July 18, 1988

The State of Alaska has reviewed the National Park Service (NPS) draft Environmental Impact Statements (EISs)/Wilderness Recommendations for the Gates of the Arctic National Park and Preserve, Wrangell-St. Elias National Park and Preserve, and Lake Clark National Park and Preserve (NPPr). The following letter is submitted on behalf of state agencies and represents a consolidation of state concerns and comments. The state's comments are presented in four sections as follows: Introductory Comments; Comments on the Specific Wilderness Recommendations; General EIS Comments; and Page-specific Comments.

TITLE: Wilderness Comments
GAAR/WRST/LACL

YAKATAT QUAD MAP A

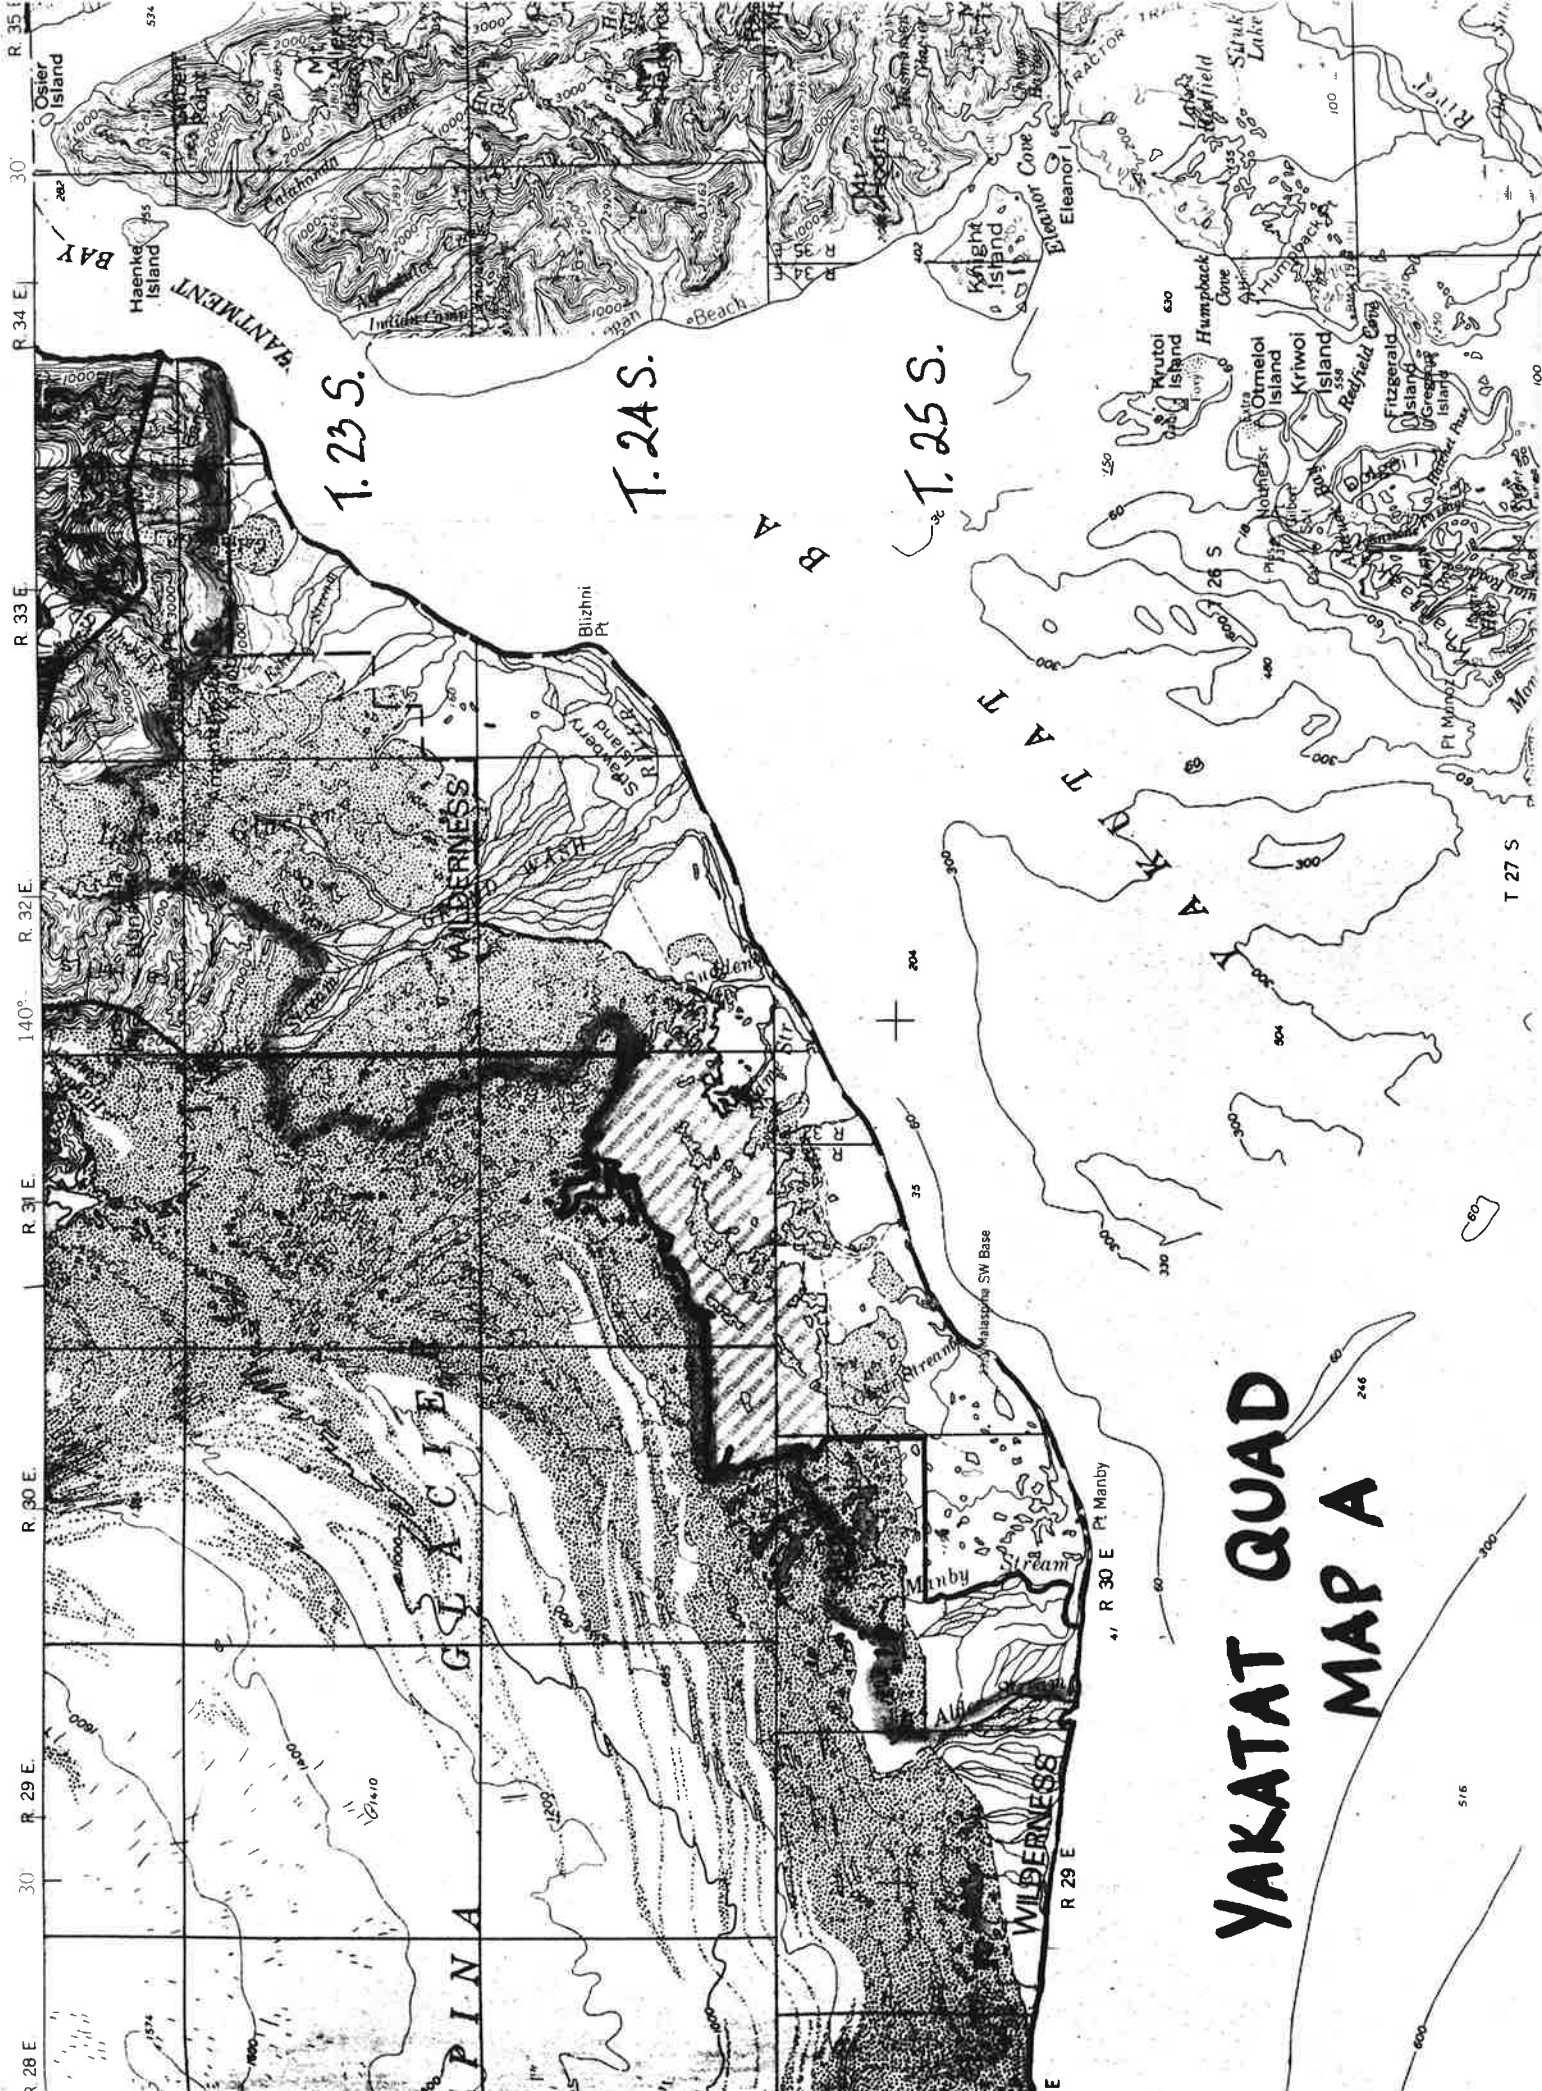
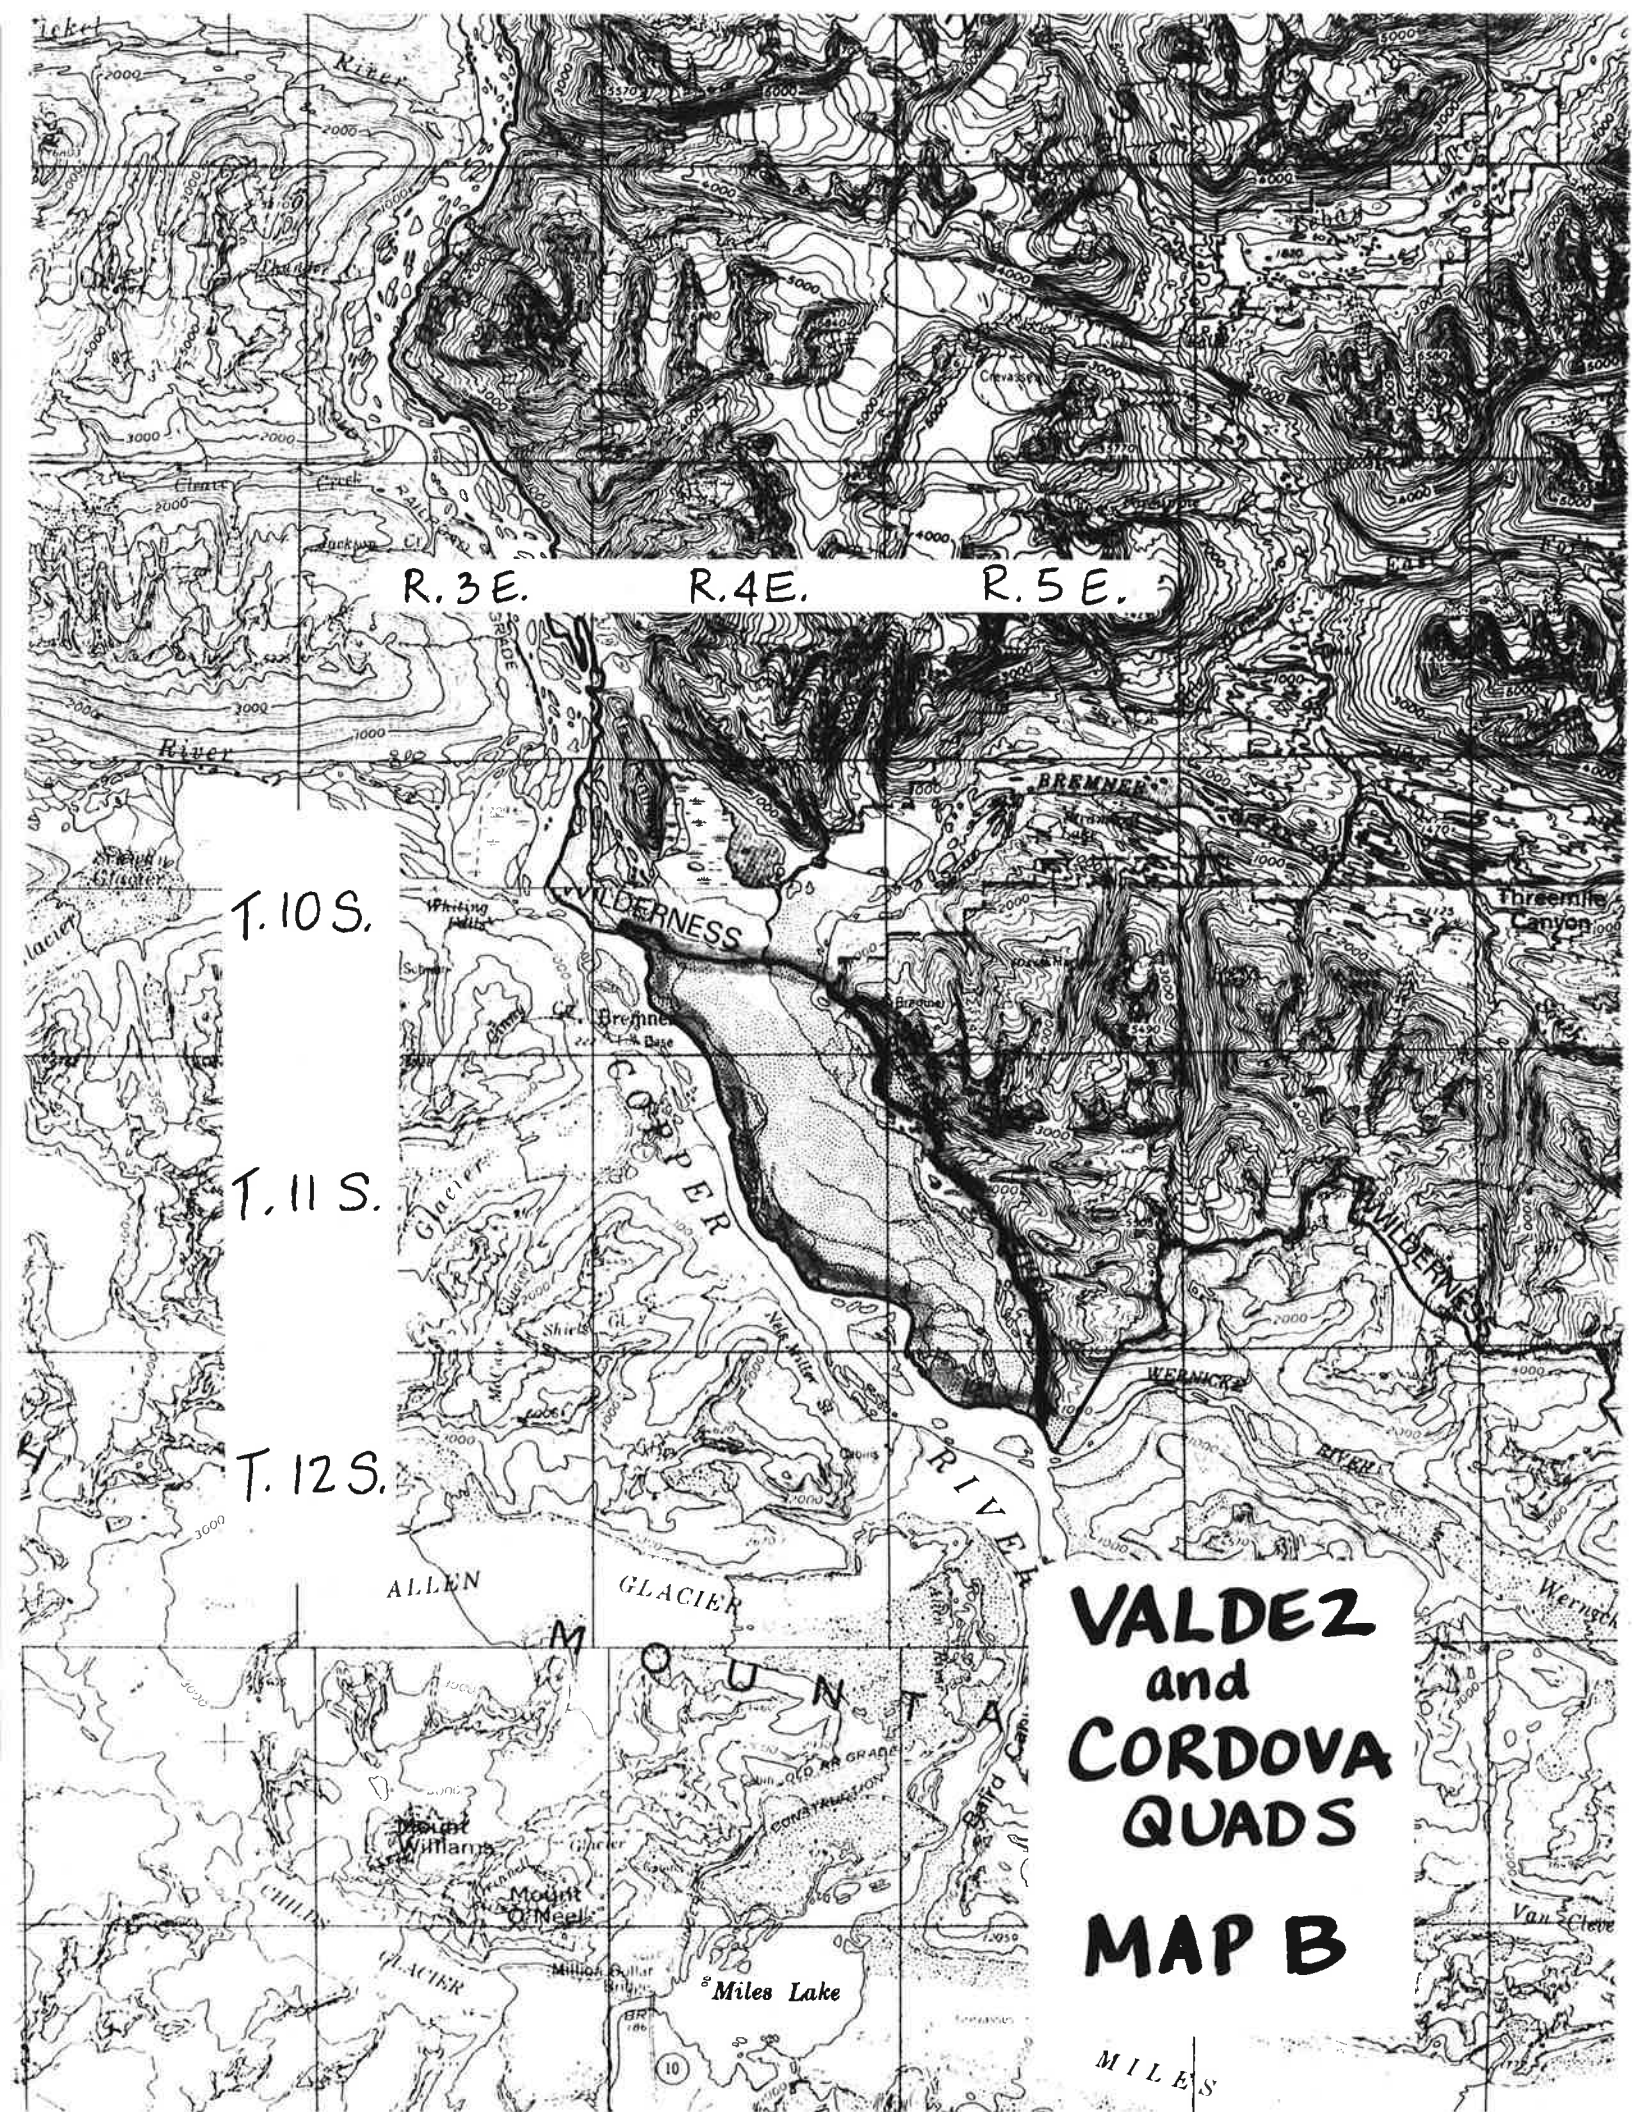
Modify the Wilderness boundary in the preserve adjacent to the Malaspina Glacier to follow more recognizable hydrographic features. (See Map A.)

- 1) This recommendation would exclude a large, un-named state-owned lake from the Wilderness boundary.
- 2) This boundary follows more easily identifiable hydrographic features and elevation contours. The glacier's edge has substantially retreated since the topographic map was made in 1961. The exposed land has re-vegetated in recent years and much of the proposed boundary is no longer recognizable in the field, even though it appears to make sense on the map. The state's proposed boundary follows more definable water bodies or steep slopes.
- 3) The lakes and washes in this portion of the preserve are relatively well used by nearby Yakutat residents for aircraft landings, boats, hunting, fishing, etc. These use levels make this area undesirable for Wilderness.

**VALDEZ
and
CORDOVA
QUADS
MAP B**

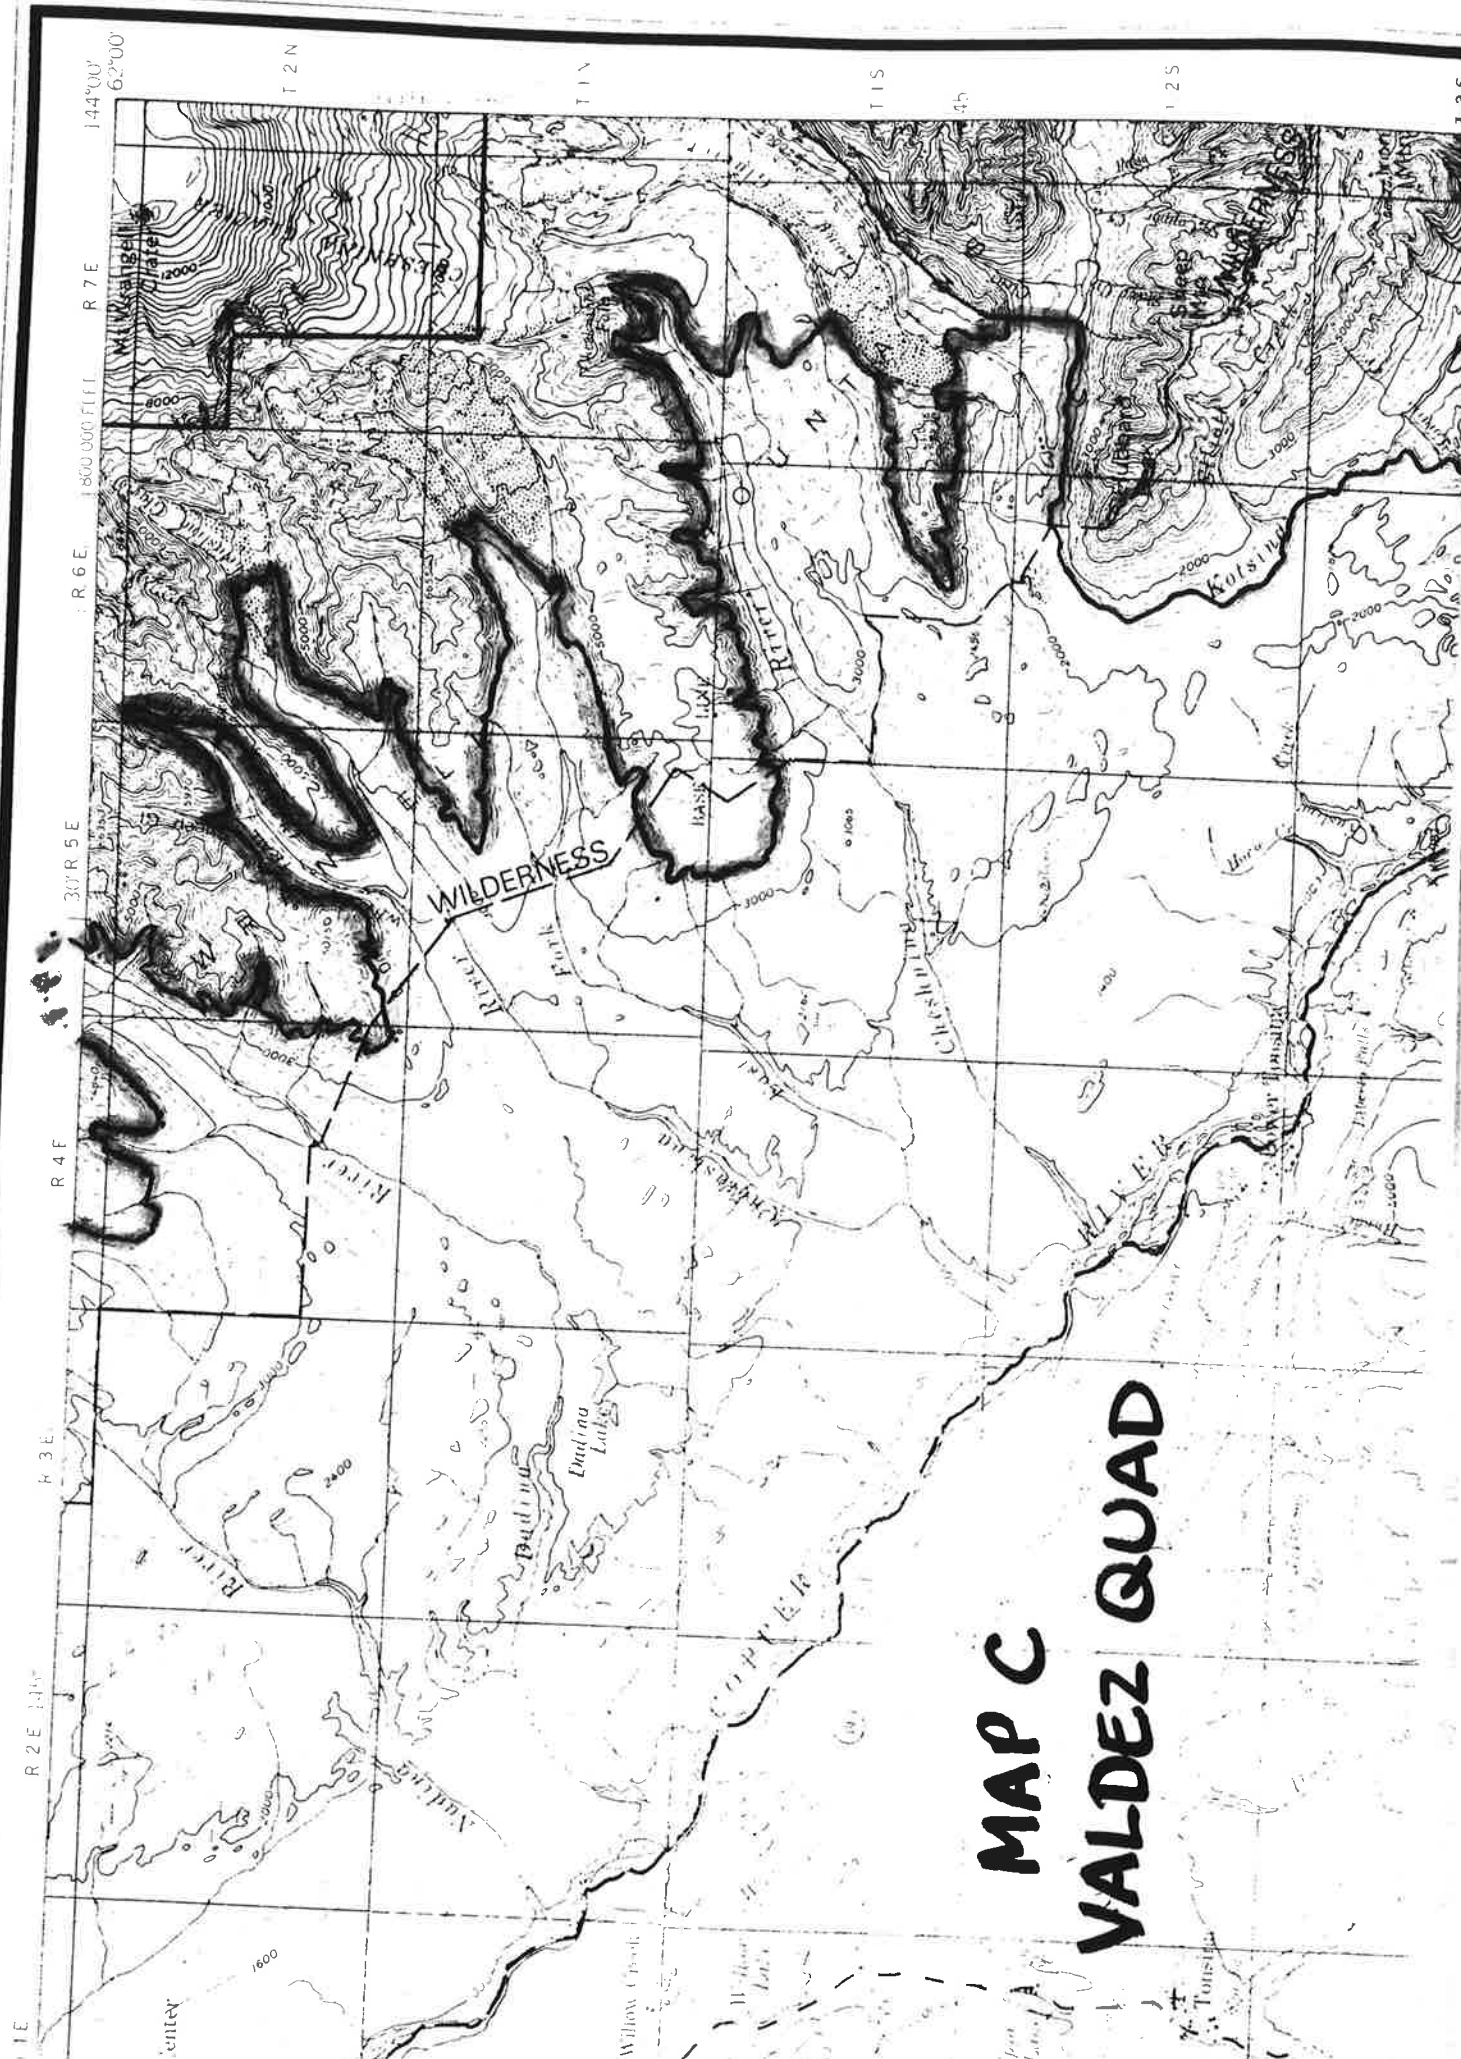
Delete the Bremner Bar from the Bremner River Wilderness recommendation. (See Map B.)

- 1) The Bremner Bar is a broad, sandy, partially vegetated river bar, portions of which are likely state-owned based on the navigability status of the Copper and Bremner Rivers. Given that the land status of this bar has not been determined and it would be difficult to base a Wilderness boundary on such uncertain status, the state recommends that the Bremner River Wilderness boundary end at the point that it enters the Copper River flat lands.
- 2) The modified boundary will be easier to locate in the field, and will thus be more manageable.
